Design Review Committee

May 14, 2025 – REGULAR MEETING

Meeting Date:	May 14, 2025	Meeting Title:	Regular Design Review Committee Meeting
Applicant:	Steller Construction	Presenter:	Katelyn Page
Item:	P25-075 - 125 E Pearl Façade Updates	Recommendation:	Final Design Review

Meeting Date:	May 14, 2025	Meeting Title:	Regular Design Review Committee Meeting
Applicant:	Jorgensen Associates (Mila Dunbar-Irwin)	Presenter:	Katelyn Page
Item:	P25-055: 139 N Cache Street Development Plan Design	Recommendation:	Final Design Review

Figure 1

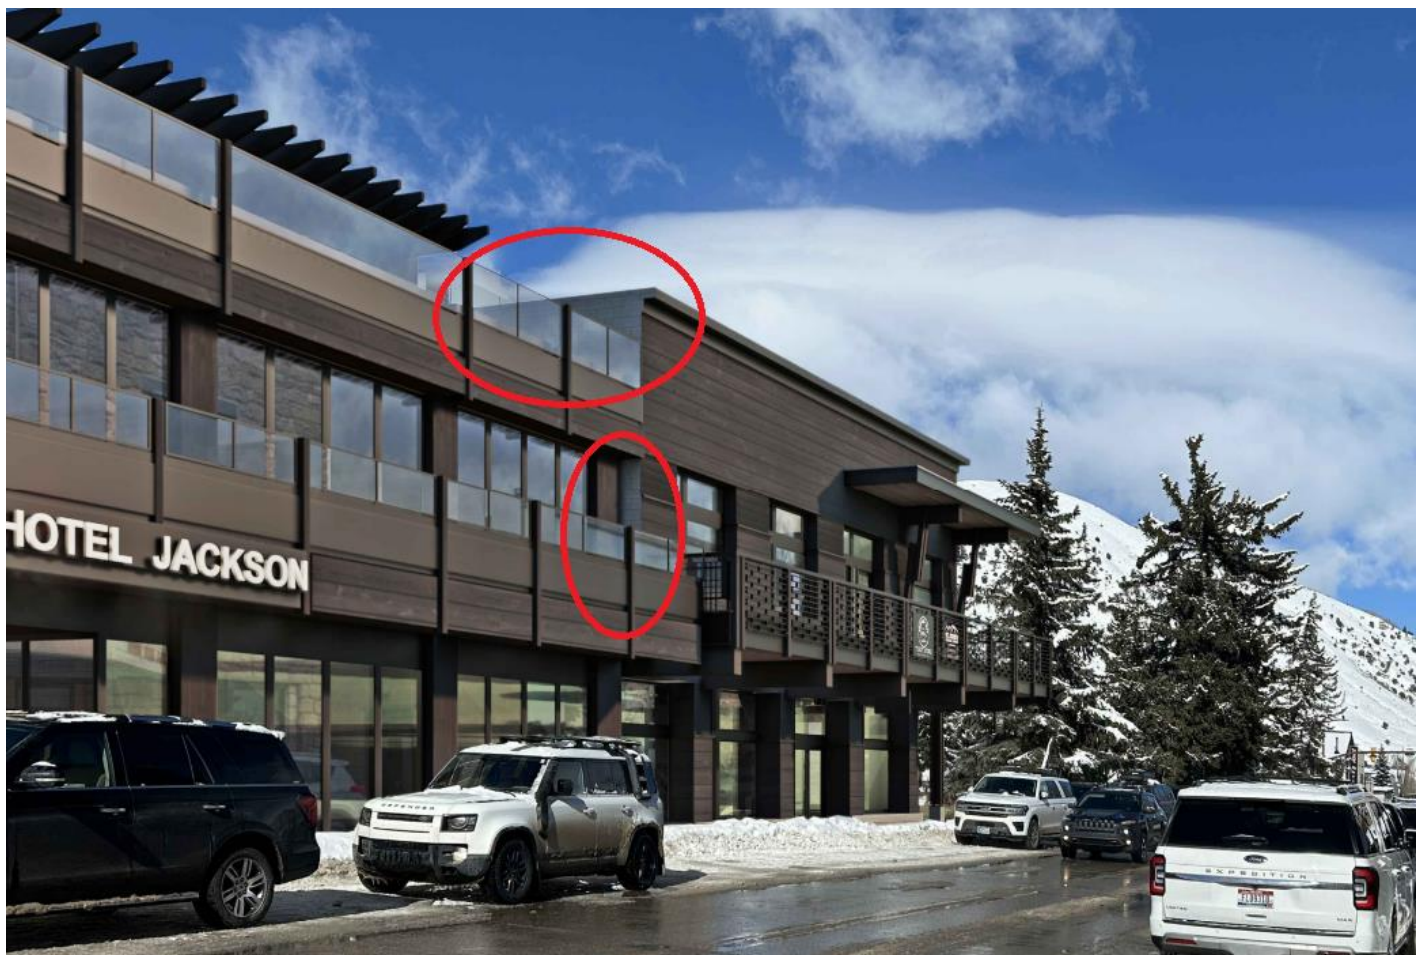
The proposed structure is 2-stories tall, measuring 35’ in height along the N. Cache Street frontage and 38’ at the western elevation. The TS-2 zone allows a maximum of 3 stories and 42’ in height, not including permitted stair and elevator overruns. Stair overruns located on the building's interior are approximately 40’ in height. Per the applicant, scale of the structure is intended to provide transition between the downtown and the broader church campus which primarily contains single story structures.

A 10’ 3rd story stepback is required in the TS-2 zone. However, the proposed 2-story Browse N Buy building is not subject to this requirement, despite having a maximum proposed height similar to the adjacent 3-story Hotel Jackson. However, as noted above, a final design will need to move the upper story wall plane back approximately 4’ to comply with the LDRs, so this will reduce, but not eliminate, the visual impact of the shared wall on the neighboring property to the south. A rendering of the proposed structure at street level as seen from the southeast is shown in Figure 1 below.
